Simple Class A Amplifier

A postscript to the design published last year

by J. L. Linsley Hood

**Fig. 2. Amended circuit of power supply for 15Ω systems.**

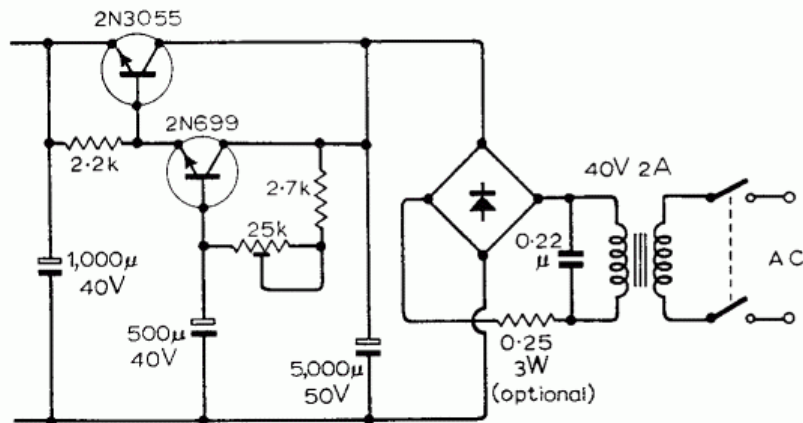
It now appears that the mains transformers used in the development of the prototype of this amplifier were not as efficient in respect of apparent secondary circuit resistance or secondary leakage reactance as some of those which have been supplied for this purpose since the publication of the article. The reservoir voltage found with the 15Ω system may be above that given by the author. At switch-on this can cause a transient overloading of the transistors specified for the series regulator circuit in the original article. In view of this, it is suggested that these should be an MJ481 or 2N3055, used in conjunction with a 2N1613 or, better still, a 2N699. These amendments are shown in Fig. 2.

Fig. 3. Alternative method of quiescent-current control. R1, R2 and C1 in the original have been deleted. Tr5 is 2N4919 on heatsink or alternative type.

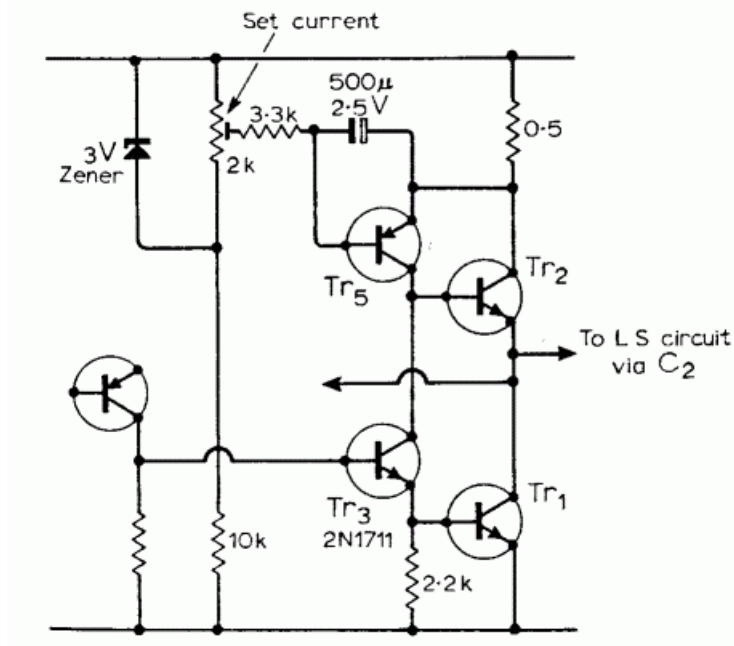
Some criticism has been voiced because there is no specific control over the output current value in the simplest form of this circuit, other than that due to the stability of the current gain of Tr2, whose performance determines this parameter. In order to meet this point (in anticipation) a circuit was described in the original article which allowed precise control over the operating 'quiescent' current without detriment to the performance of the amplifier.

However, measurements made on an amplifier without this addition have shown no significant change in operating current in somewhat over two years use, and there is also little measurable difference in current from a minute or so after switch-on to the end of a six-hour period of continuous use. In practice therefore, in temperate climates at least, the simplest form of the circuit is adequate in this respect. If any user cares to experiment with an alternative and somewhat more elegant form of quiescent-current control another regulation circuit is shown in Fig. 3. The transistor used as Tr5 requires to be somewhat more massive than that used for Tr3 since the mean collector current is twice that of Tr3 and the maximum voltage and current occur simultaneously. The 2N2905A is just about adequate with a good heatsink, but a larger power device such as the 2N4919 is preferable.

Fig. 4. Scheme for 30W class-A system. The two identical class-A amplifiers, each designed to give 15W into 8Ω (34V at 1.5A), are driven by a phase-splitter. The output capacitors have been removed.

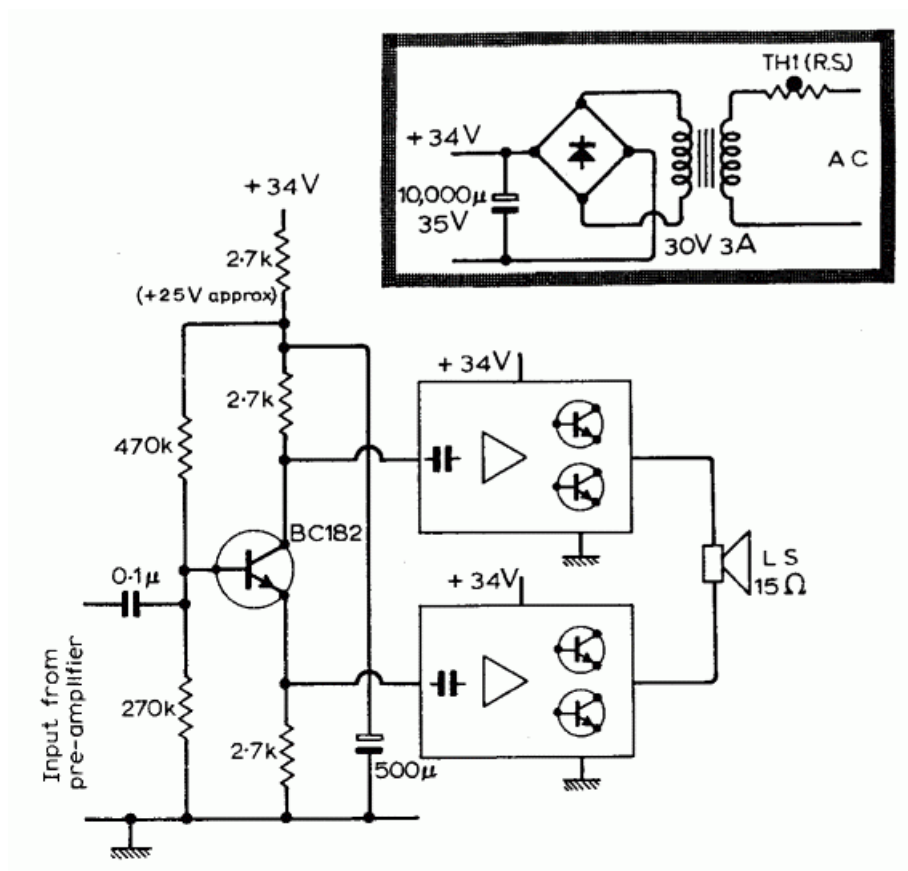
The amplifier has been built successfully with a wide variety of transistors, including fully complementary versions to operate from an existing negative h.t. line, and in one case two identical amplifiers have been made for use with the inputs in paraphase, in order to double the available output voltage swing. One constructor has, indeed, made a stereo 30W system using two such pairs of amplifiers plus input phase splitter, as shown in Fig. 4.
